Hill Country Portion of the Trinity Aquifer System Groundwater Availability Model: Update

Texas Water Development Board

August 17, 2009

1. **Purpose of meeting:** Stakeholder Advisory Forum for the Groundwater Availability Model of the Hill Country portion of the Trinity Aquifer System
2. **Date and location of meeting:** August 17, 2009

RECHARGE

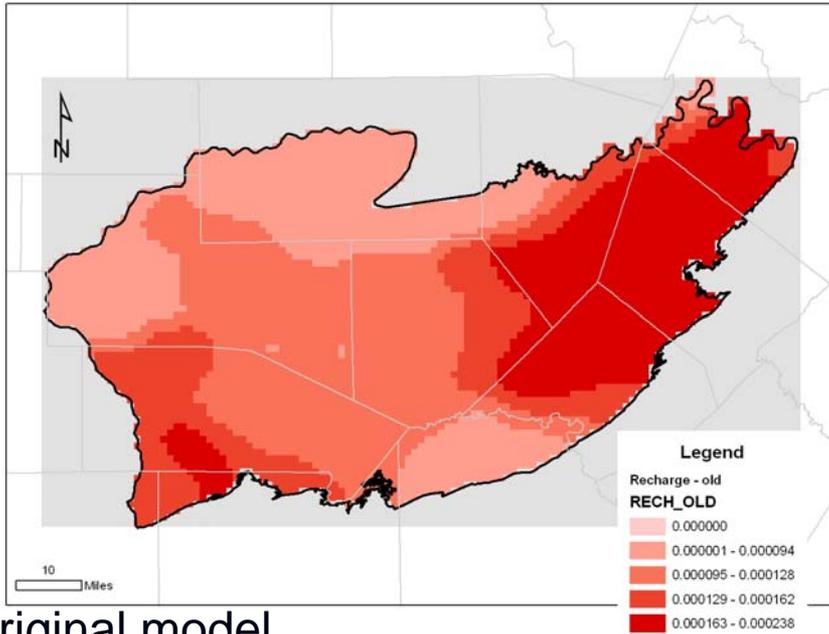
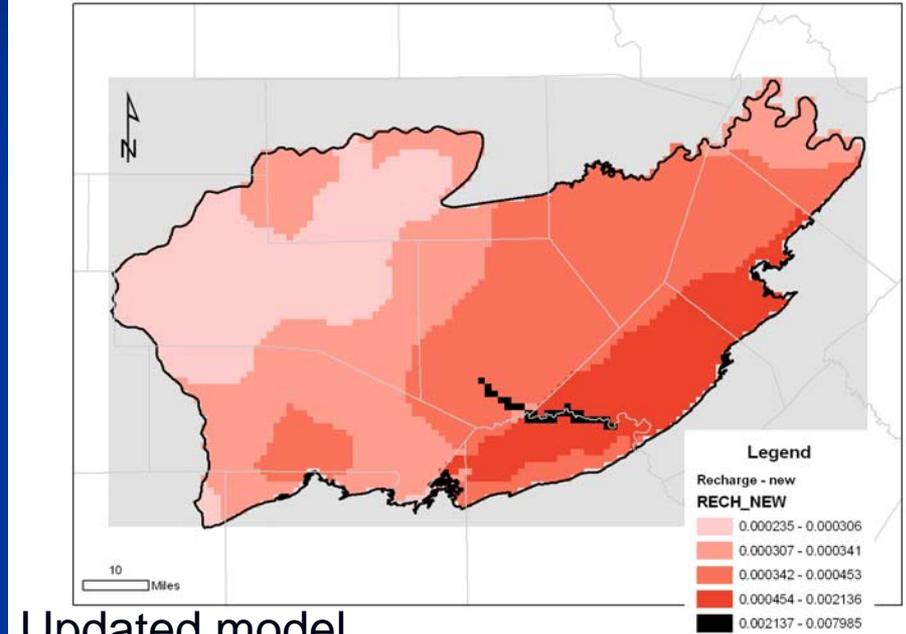
- **Isn't the baseflow analysis methodology used in the original model more constrained than the fixed fraction of precipitation method used in the**

updated model? *The weakness of the baseflow method is that it does not consider groundwater flow between watersheds.*
